Product Change Notification - SYST-26RFQV779

ERRATA - KSZ9477S Silicon Errata & Data Sheet Clarification Errata Document Revision

KSZ9477S Silicon Errata and Data Sheet Clarification

FIGURE 1: IEEE DOCUMENT PAGE 6

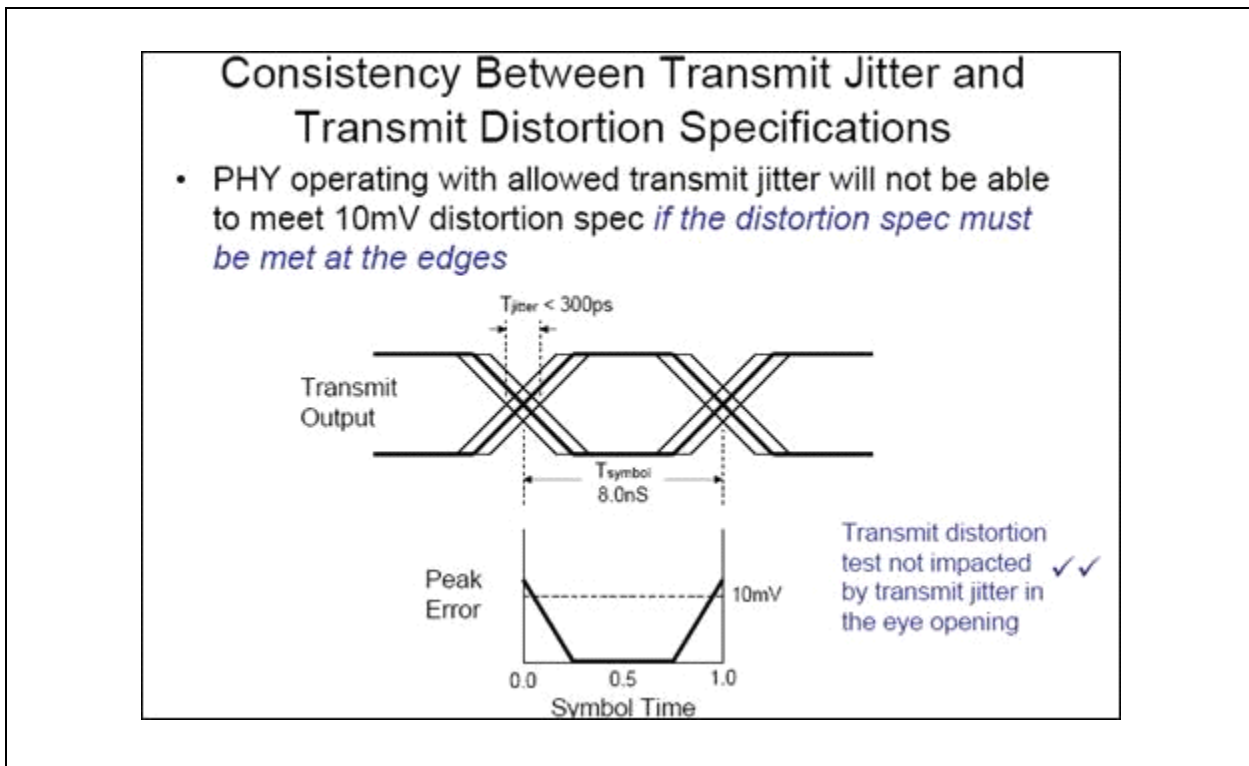
It is unlikely this specification failure will impact system performance. The following link to the Gigabit Transmit Distortion Testing document on the IEEE802.org website also questions the validity of this measurement:

IEEE testing calls for <10mV peak transmitter distortion for at least 60% of the UI within the eye opening. However, this measurement might not be valid, as the transmit distortion test is sensitive to transmit jitter. Refer to the explanation below, taken from the aforementioned IEEE document.

- On page 6, a contradiction between Transmit Jitter and Transmit Distortion requirements:

None.

FIGURE 2: IEEE DOCUMENT PAGE 7

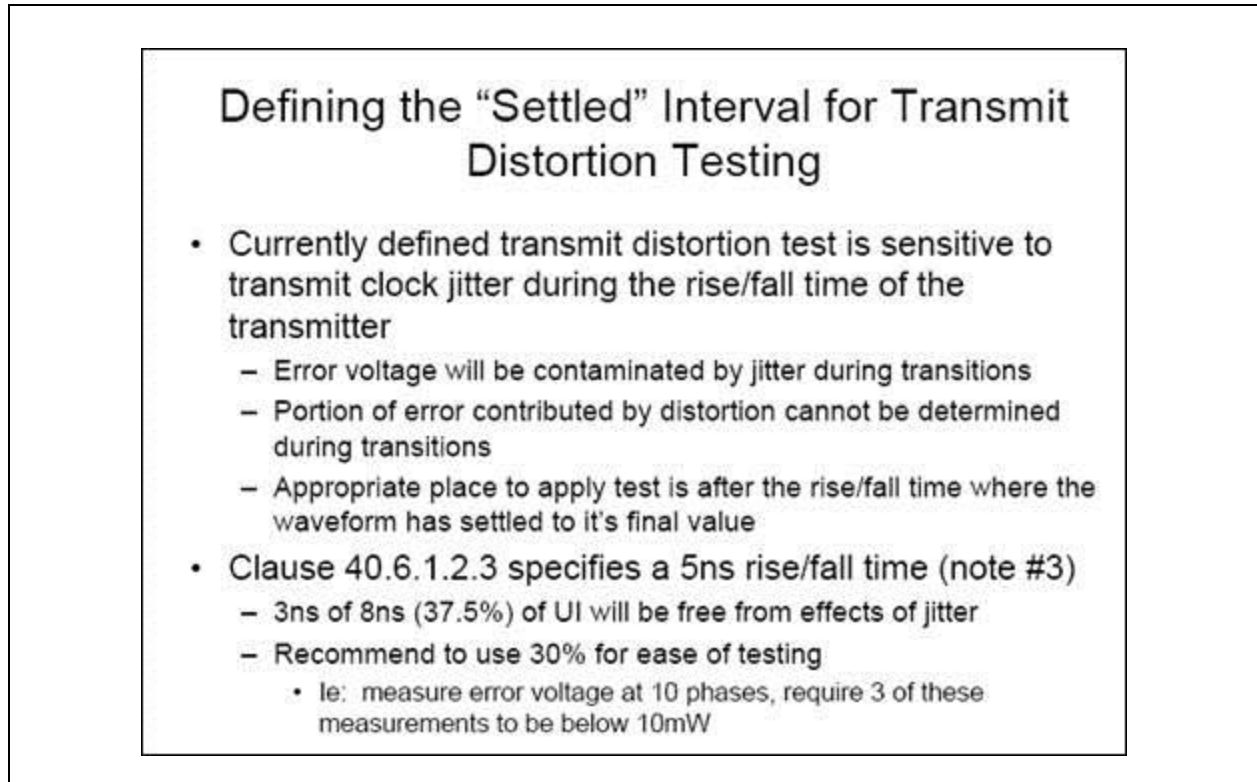
- On page 7:
 - The transmit distortion test is sensitive to transmit clock jitter during the rise/fall time.
 - It is recommended to change the requirement to use at least 30%, instead of at least 60%, of the UI within the eye opening for the <10mV peak transmitter distortion.
